GEOSHIELD Verification Report

McAlear & Rushe

101 Charles Street

AREA SURVEYED: Pile Cap on A10 and B6 and Cores D7 and D5

LOCATION/GRID LINE: Pile cap on A10

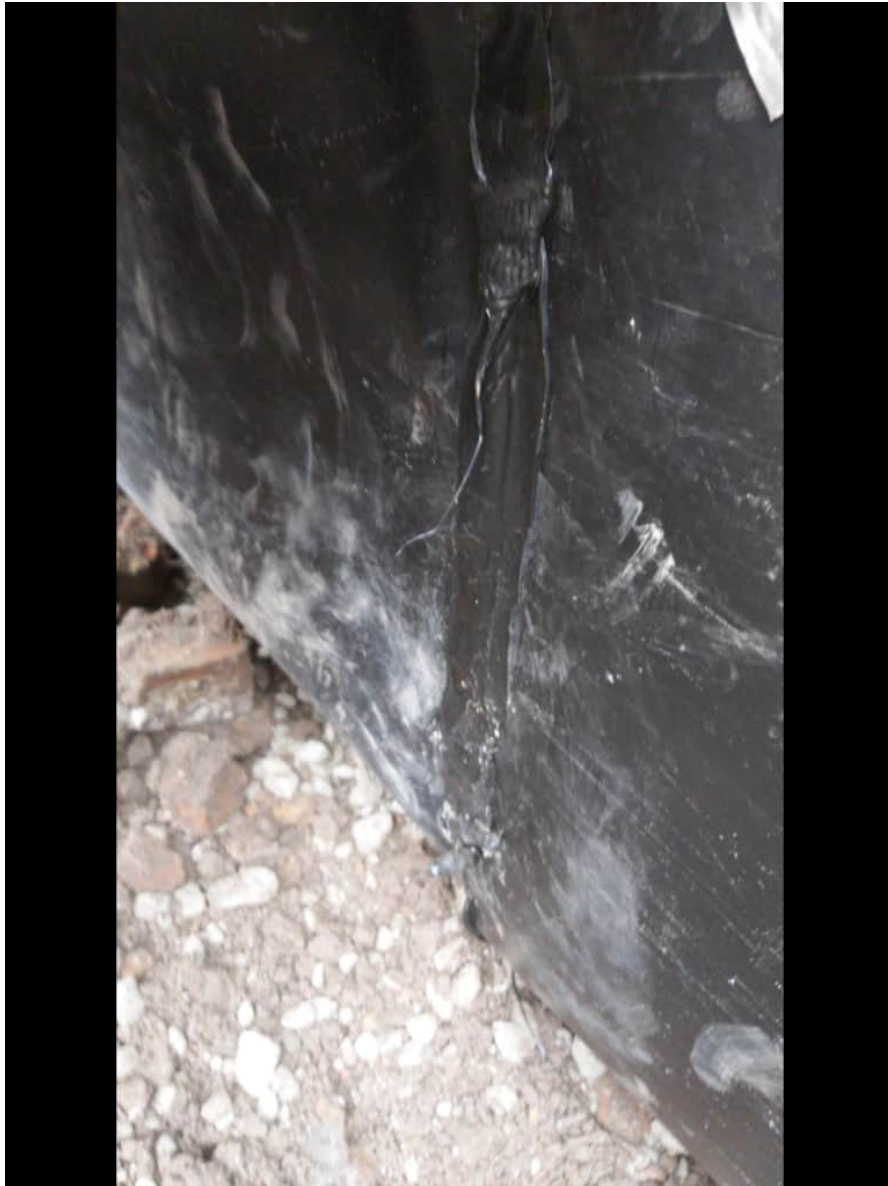
NOTES: Pile cap on A10 wrapped with Visqueen Ultimate

Geoseal with joints hot welded and extrusion welded. Correct spacers used and membrane lapped under pile cap 200mm as per design detail.

1. Steel rebar covered with tric trac spacers before being wrapped

2. Pile cap wrapped with Geoseal and sealed with extrusion welds

LOCATION/GRID LINE: Core D7 and D5

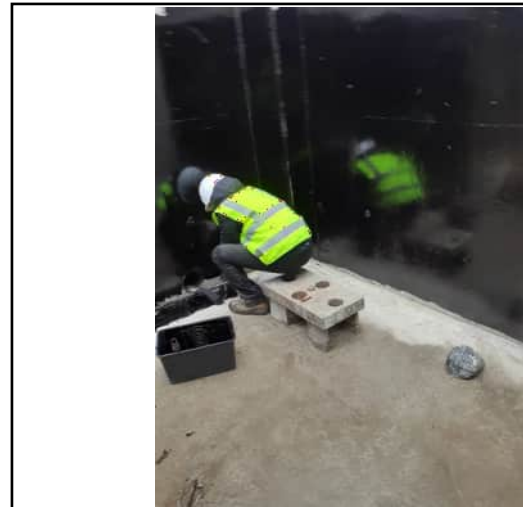
NOTES: Core D5 is now complete. Core D7 is on going and

requires water removing from the base to allow a good seal with the GR SAM.

Further prep works required on D7 as done with D5

1. Base of D5 swept clear of standing water and dried with a blow torch.

2. Base of D5 dry enough for bitumen primer before GR SAM applied.
